Free wheel pulley alternator
Change design

FAPU Kit

VKM 03604

Free wheel design upgrade:

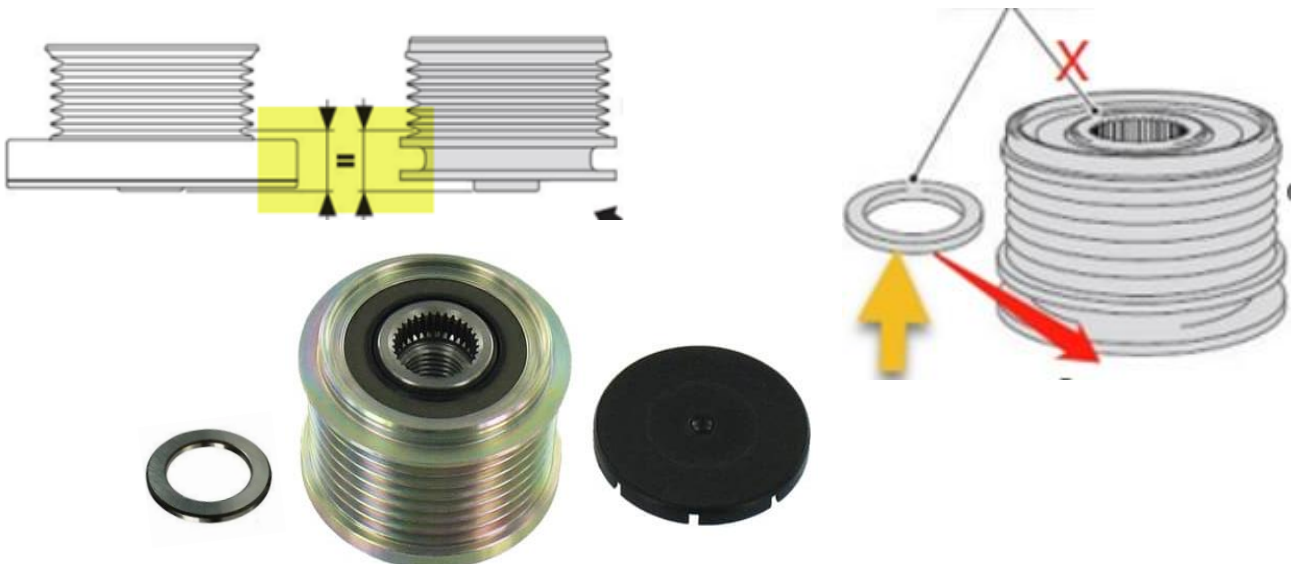
- Due to design standardization, here is our proposal completely interchangeable with the old one.
- Based on customer requirements, a cap has been added to avoid dirt, and a ring (put on the bottom), to increase the first slot distance of OAP
